Register Reference : 91A/1425

Development : Development of 80 two storey terraced, semi-detached
houses and bungalows, also shop and creche

LOCATION : off Old Court Road, Firhouse, Tallaght

Applicant : Cunningham Group

PP 30.08.91	drawn	date 29.08.91
	check	scale 1:50
	drawing	SHOP/CRECHE PLAN & FRONT ELEVATION
	Contract	FIRHOUSE, TALLAGH
	revisions

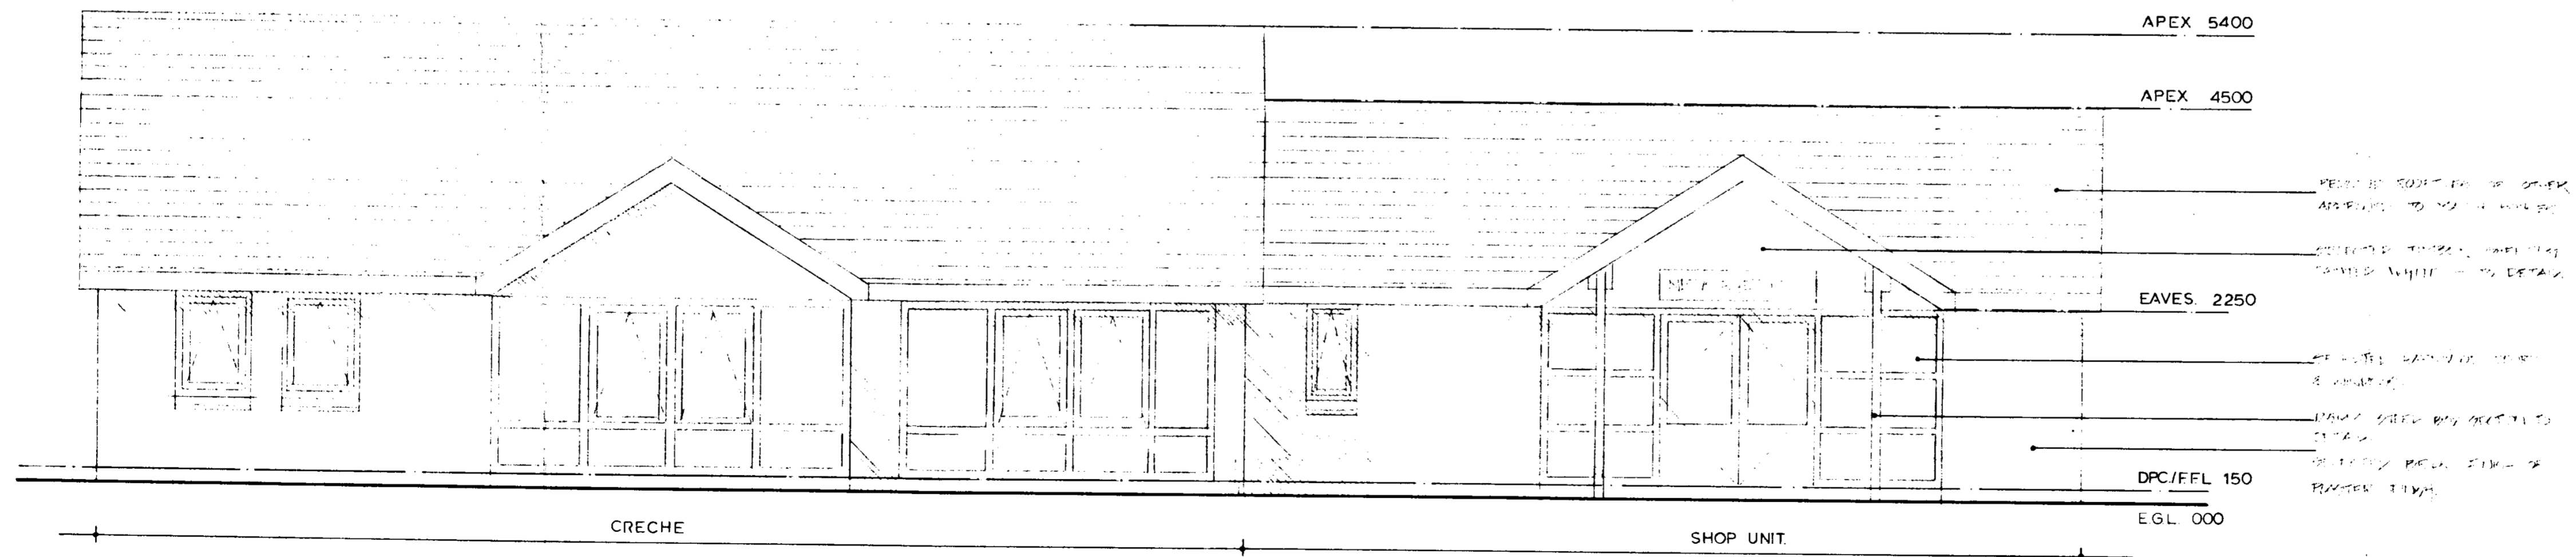
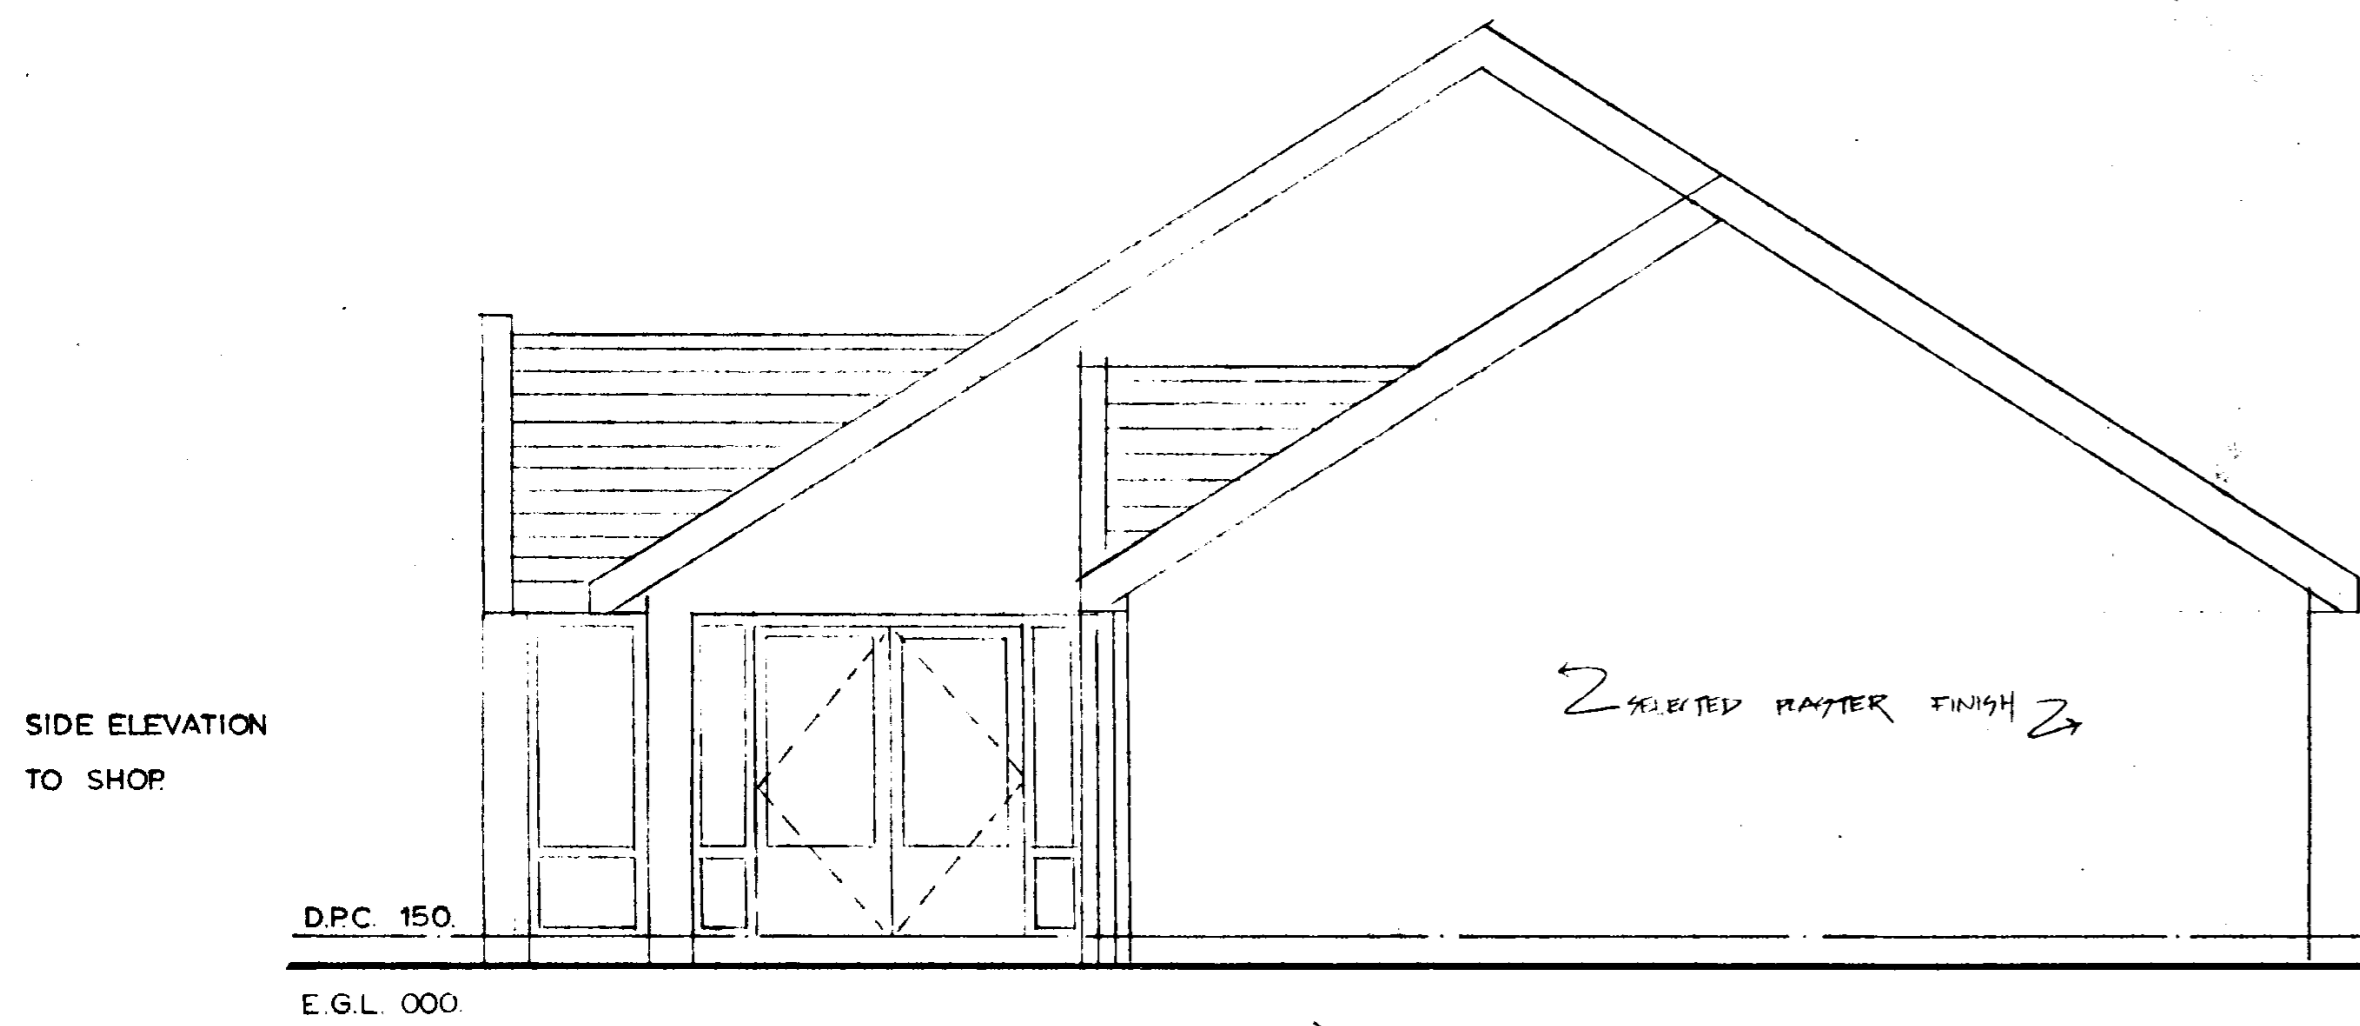
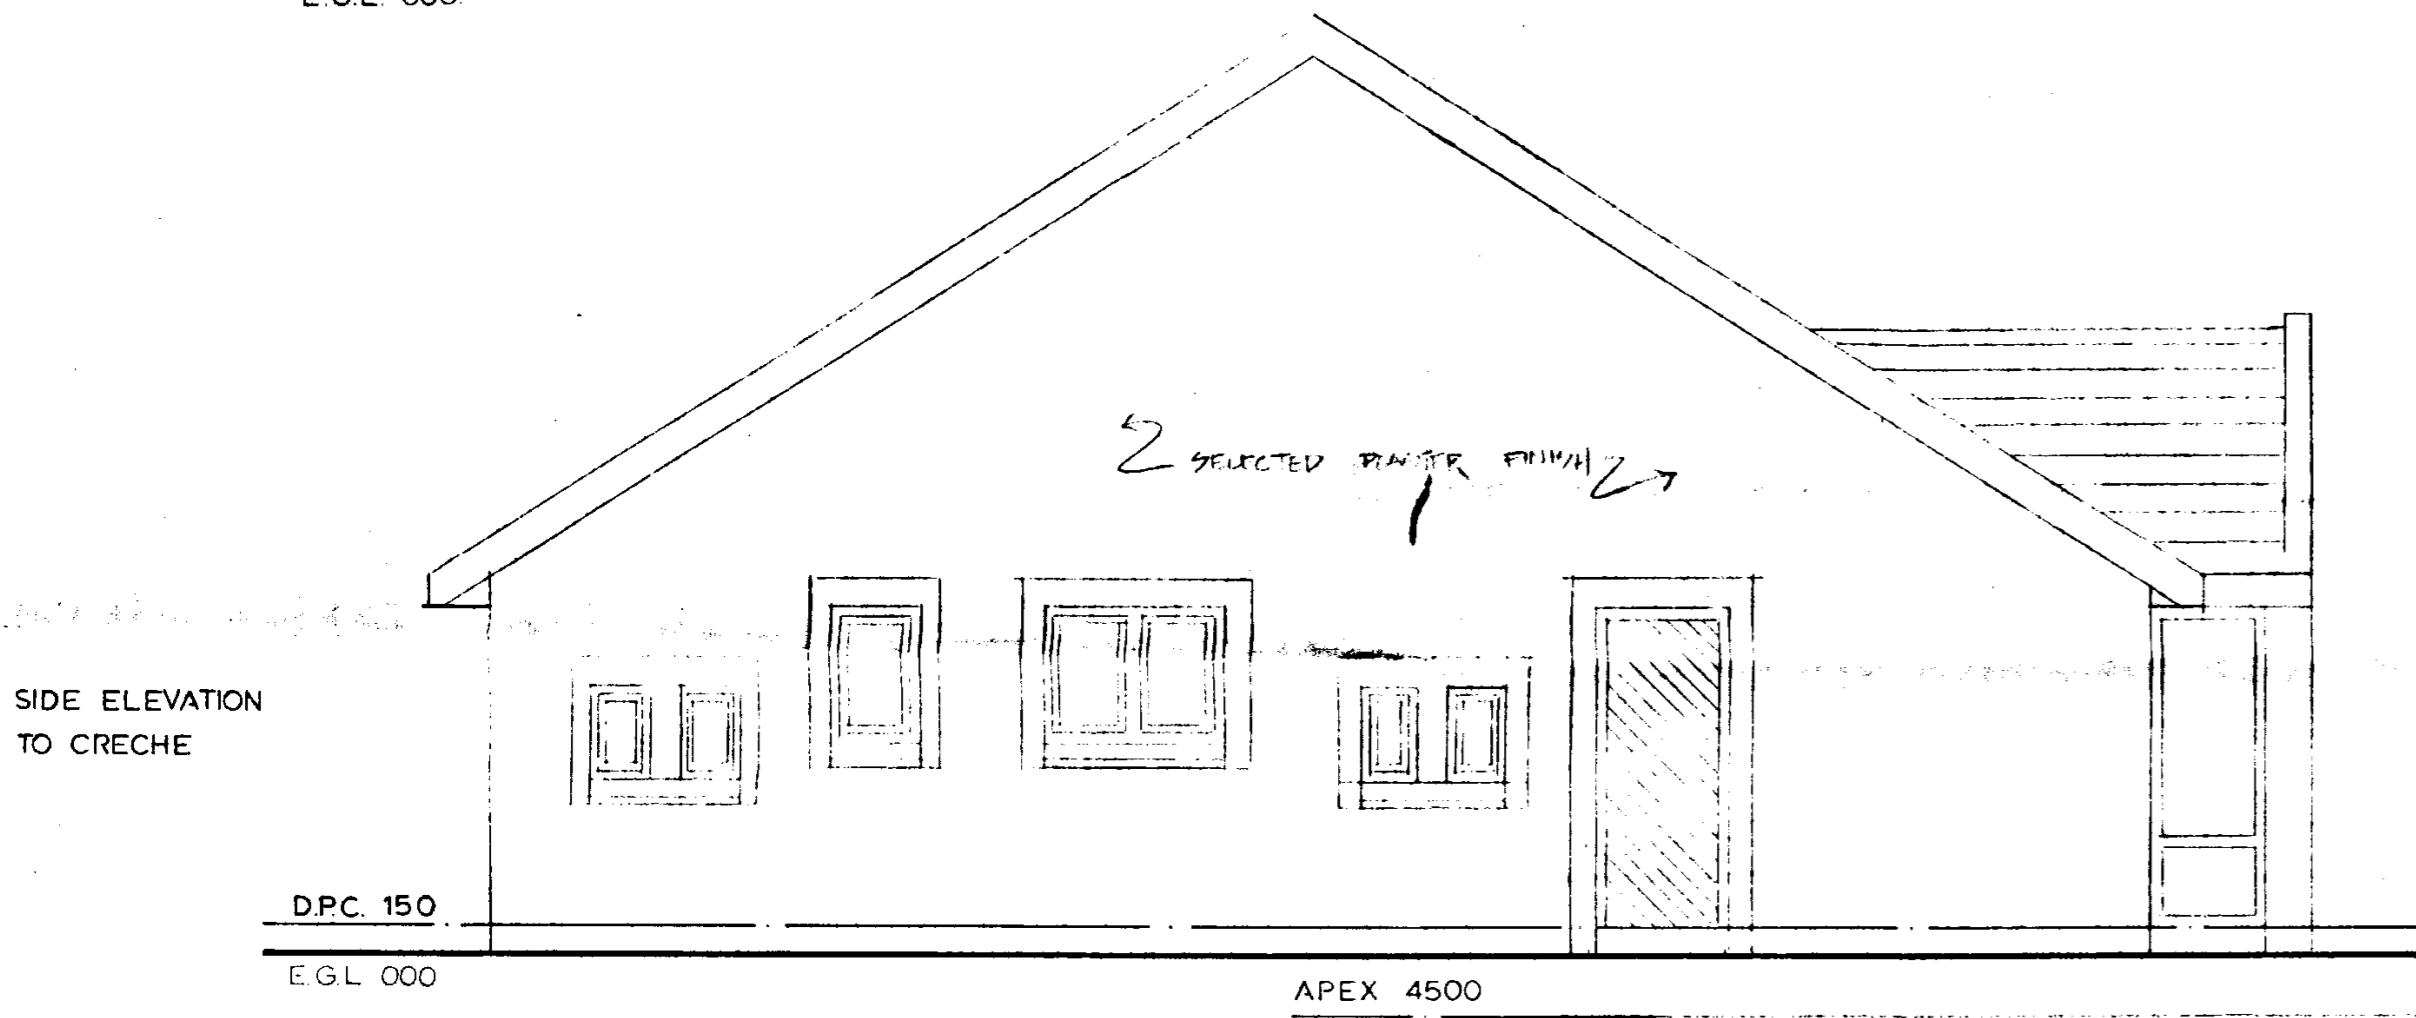
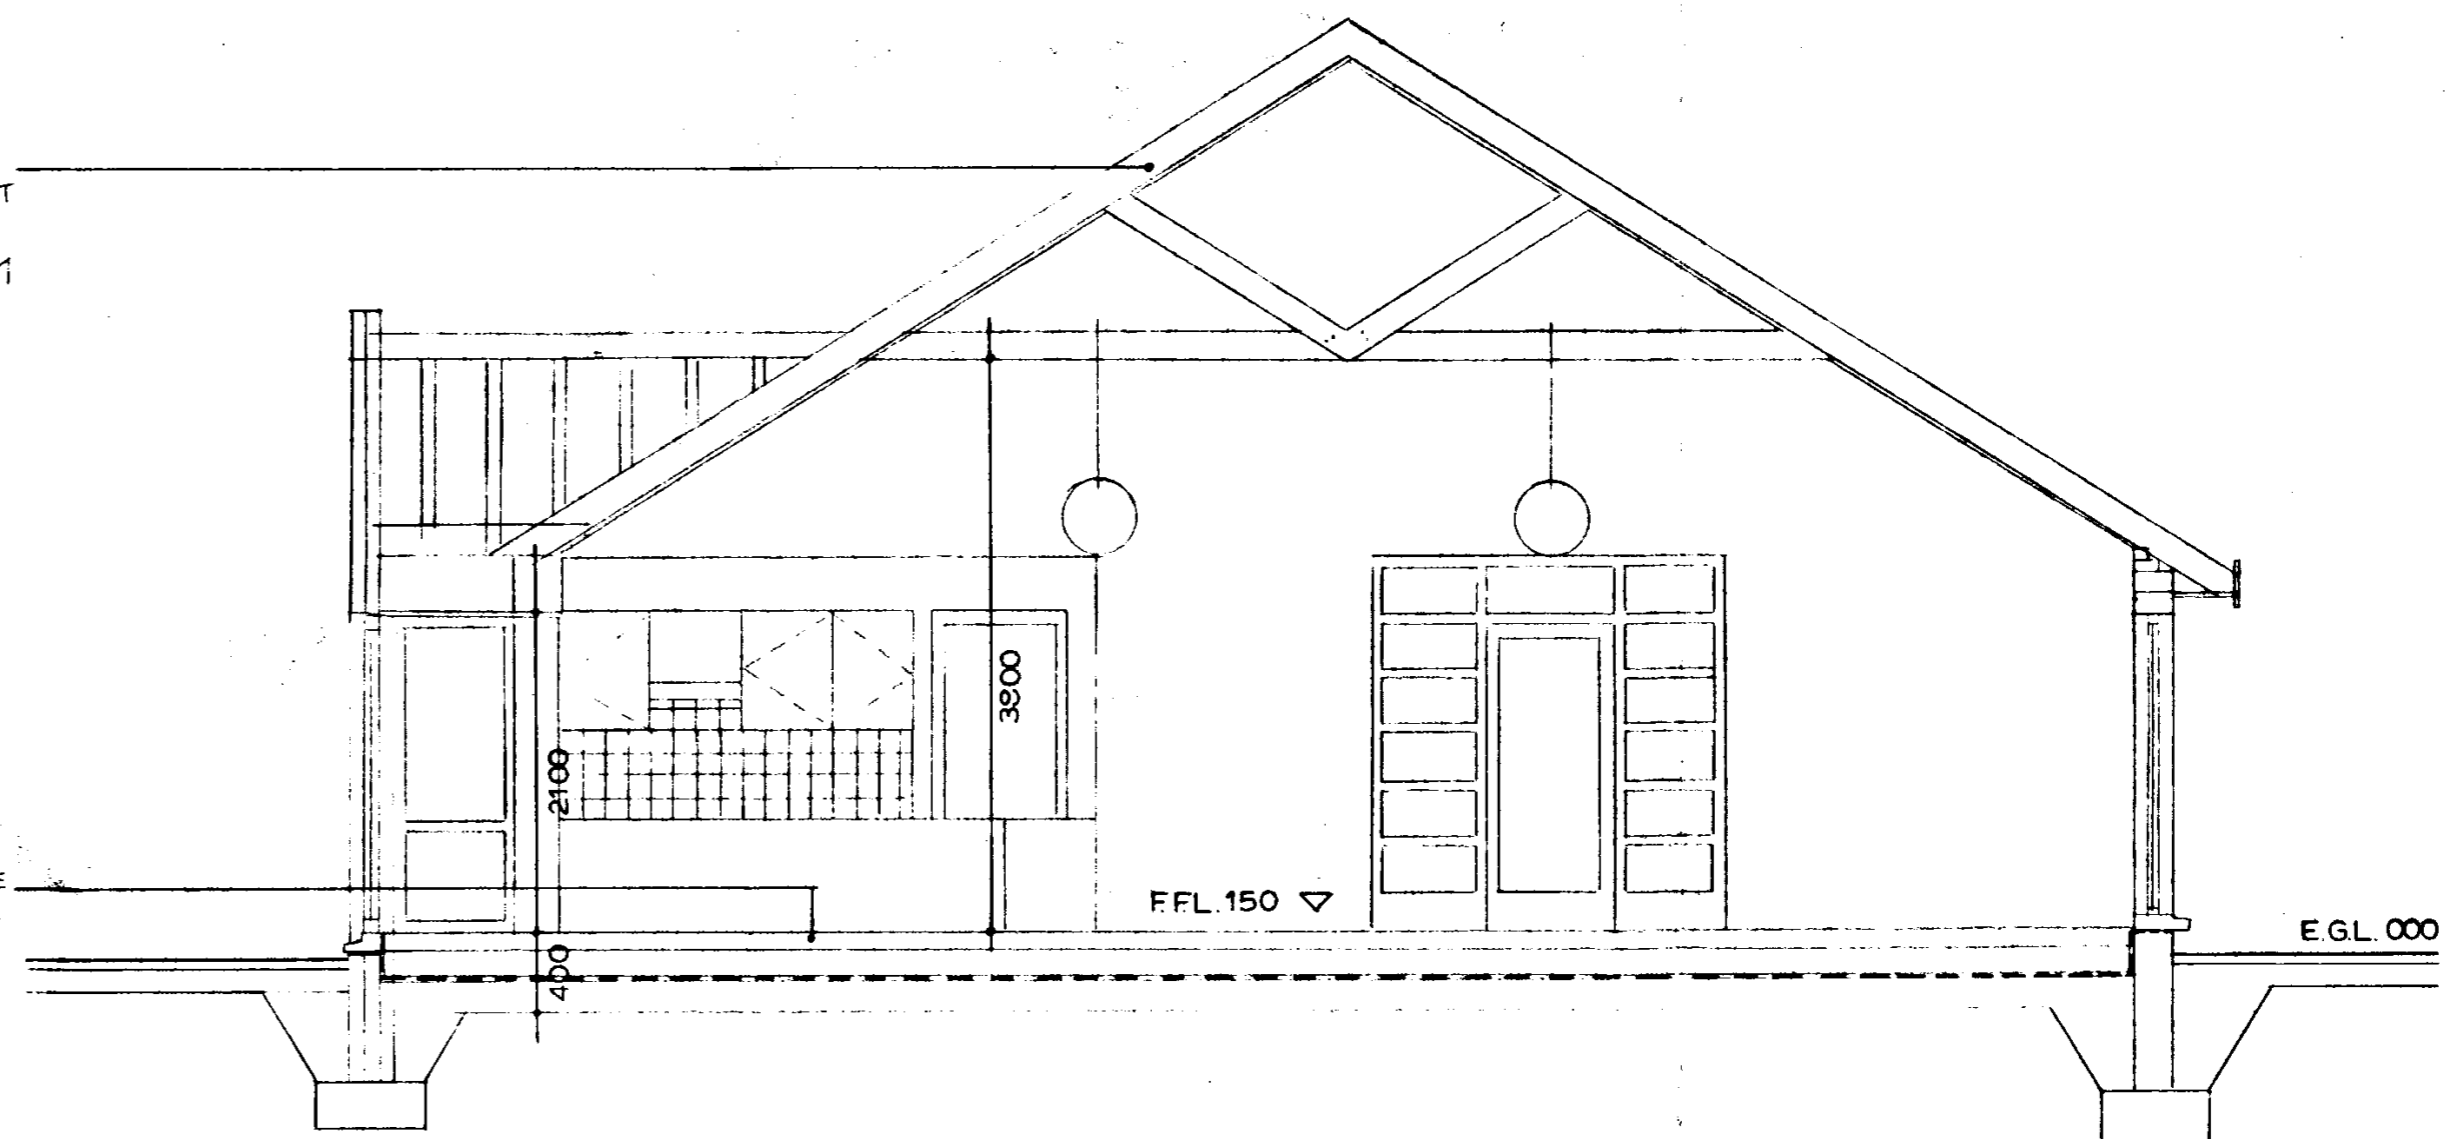
C) THE PROPOSED ENTRY TO THIS SHOP AND CRECHE IS SITED NEXT TO A VERY DANGEROUS CORNER IN THE ROAD WHICH HAS ALREADY SEEN NUMEROUS ACCIDENTS.

MA/BMOC 4a The proposal does not provide for access to that distributor route (the shop & creche are in the line)
